5TH ST CONDITIONAL USE PERMIT

PRELIMINARY LANDSCAPE PLAN

CITY OF PUYALLUP

EN-03

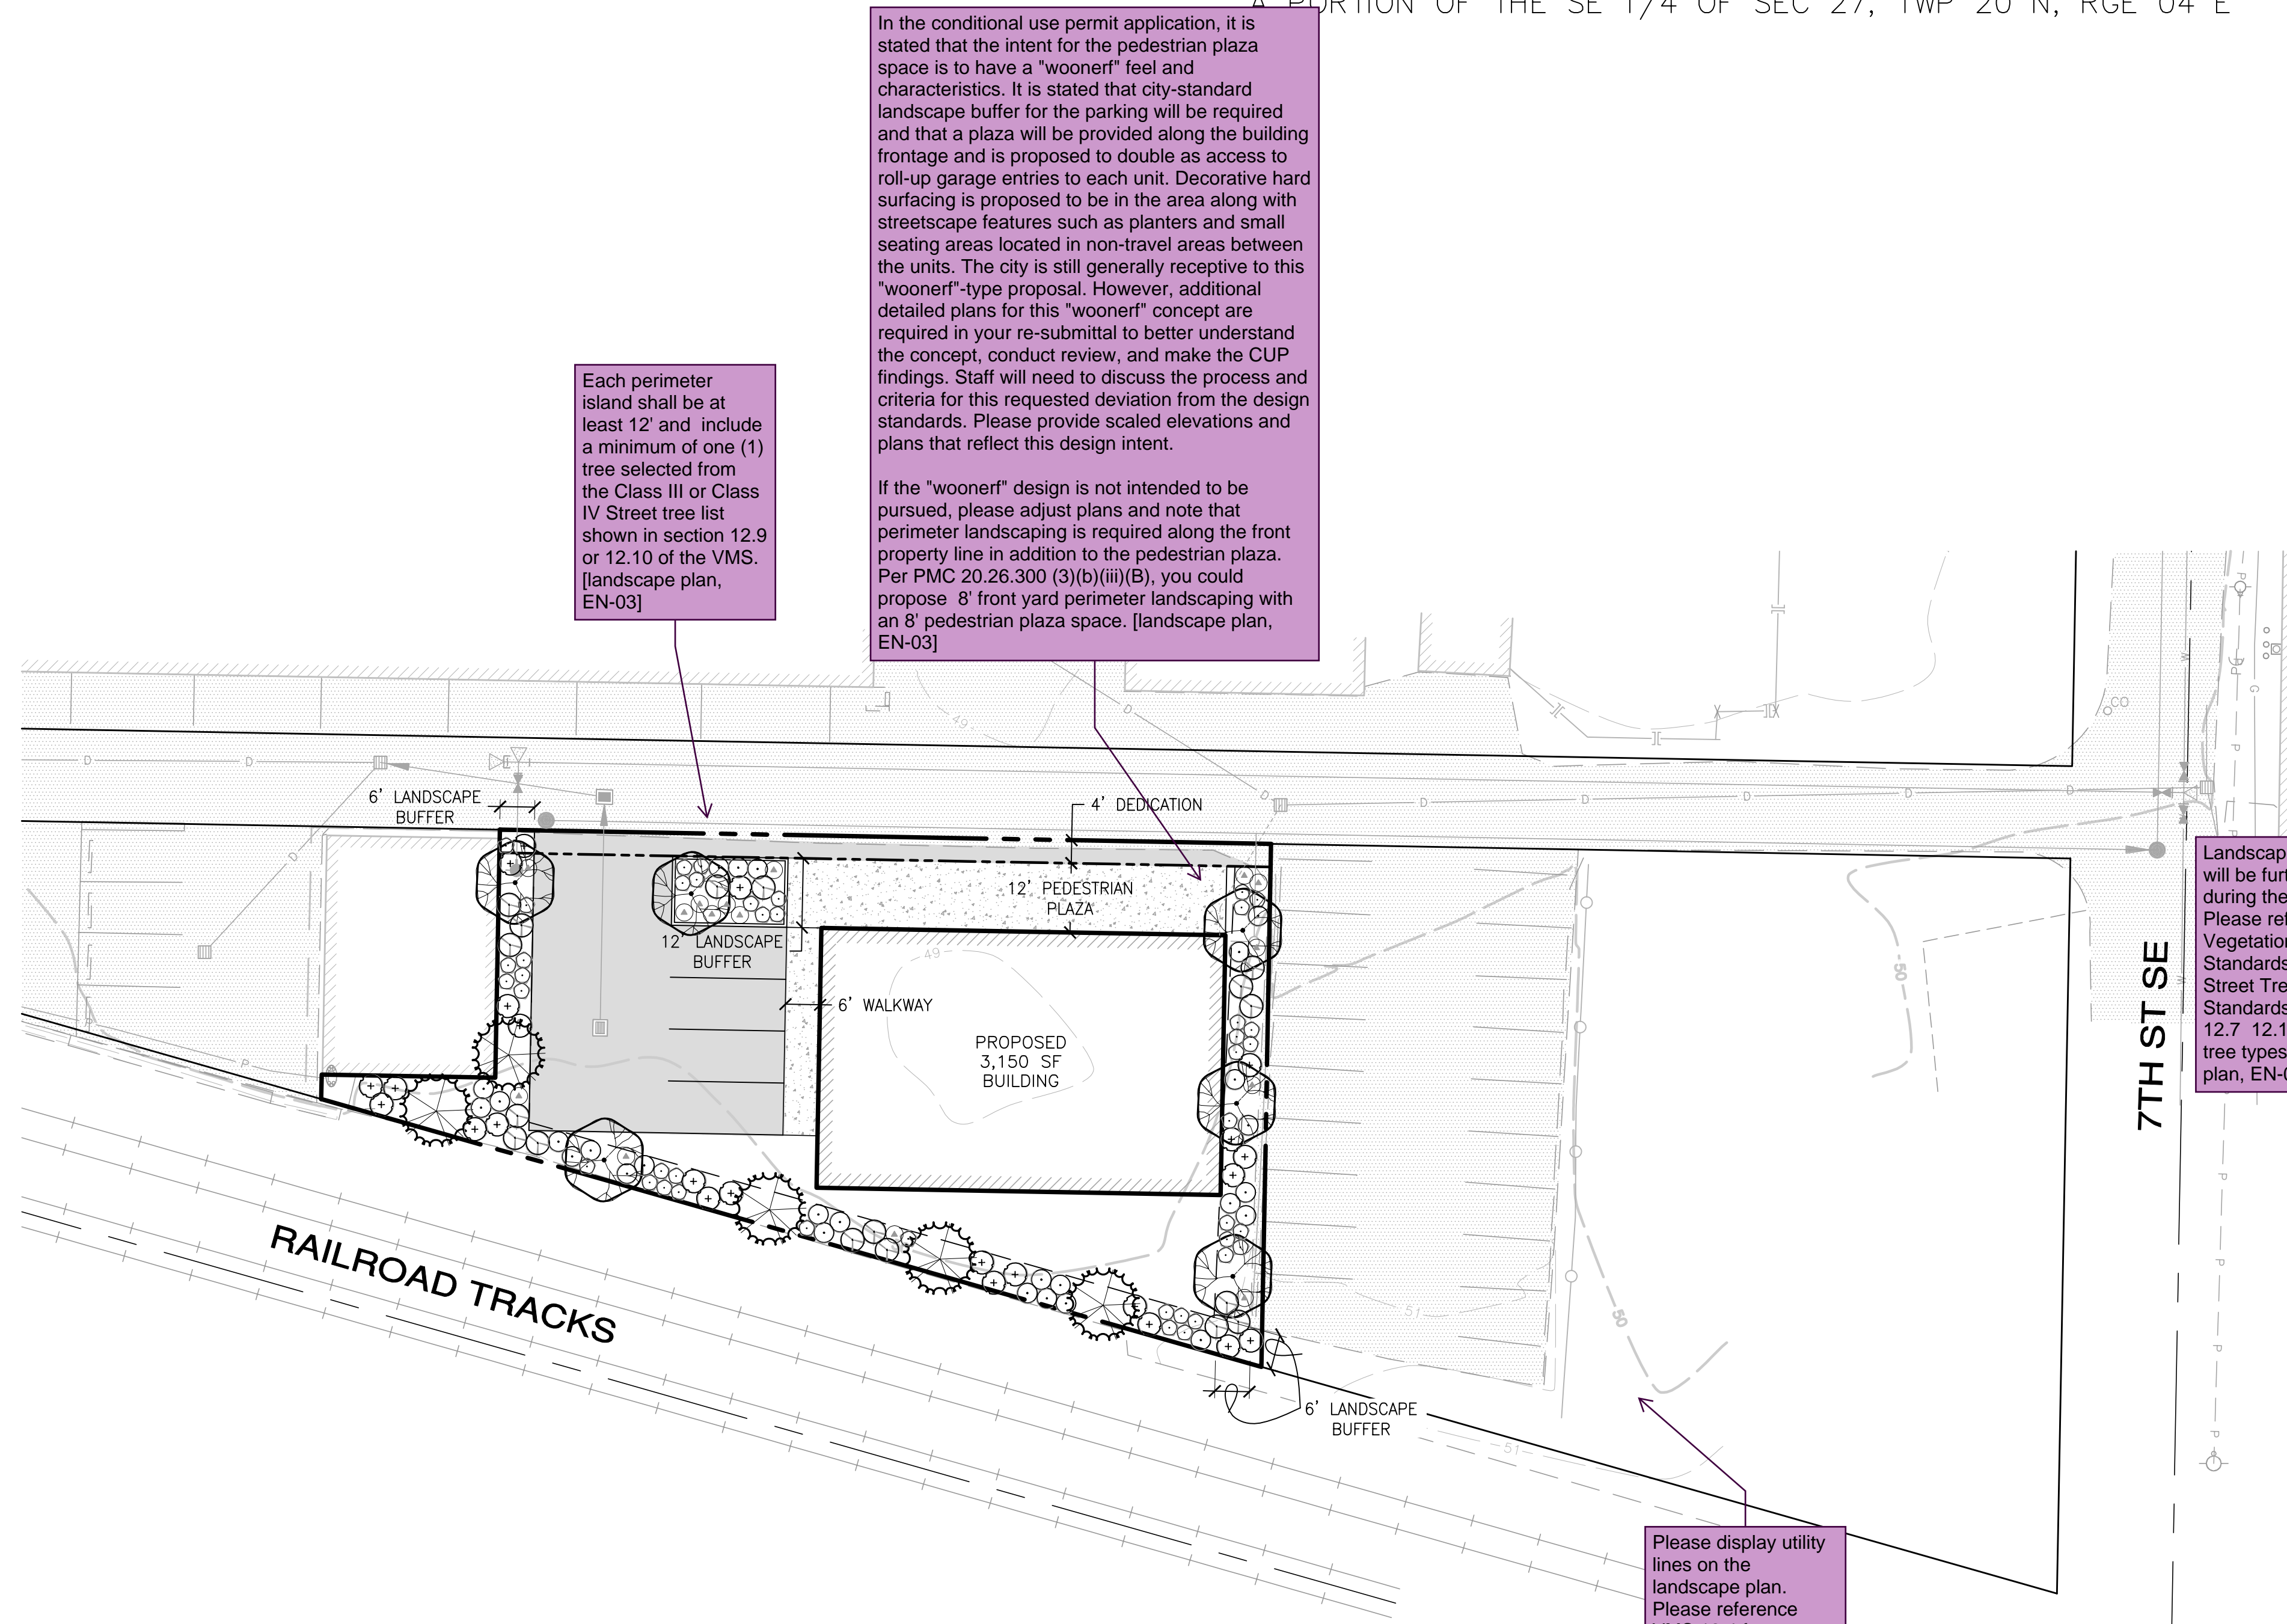
Each perimeter island shall be at least 12' and include a minimum of one (1) tree selected from the Class III or Class IV Street tree list shown in section 12.9 or 12.10 of the VMS. [landscape plan, EN-03]

In the conditional use permit application, it is stated that the intent for the pedestrian plaza space is to have a "woonerf" feel and characteristics. It is stated that city-standard landscape buffer for the parking will be required and that a plaza will be provided along the building frontage and is proposed to double as access to roll-up garage entries to each unit. Decorative hard surfacing is proposed to be in the area along with streetscape features such as planters and small seating areas located in non-travel areas between the units. The city is still generally receptive to this "woonerf"-type proposal. However, additional detailed plans for this "woonerf" concept are required in your re-submittal to better understand the concept, conduct review, and make the CUP findings. Staff will need to discuss the process and criteria for this requested deviation from the design standards. Please provide scaled elevations and plans that reflect this design intent.

If the "woonerf" design is not intended to be pursued, please adjust plans and note that perimeter landscaping is required along the front property line in addition to the pedestrian plaza. Per PMC 20.26.300 (3)(b)(iii)(B), you could propose 8' front yard perimeter landscaping with an 8' pedestrian plaza space. [landscape plan, EN-03]

Landscaping plant types will be further reviewed during the civil application. Please reference the Vegetation Management Standards (VMS) 12.4 Street Tree Installation Standards Table and VMS 12.7 12.10 for allowed tree types. [landscape plan, EN-03]

Please display utility lines on the landscape plan. Please reference VMS 12.4 for street tree installation standards table that outlines required spacing. [landscape plan, EN-03]
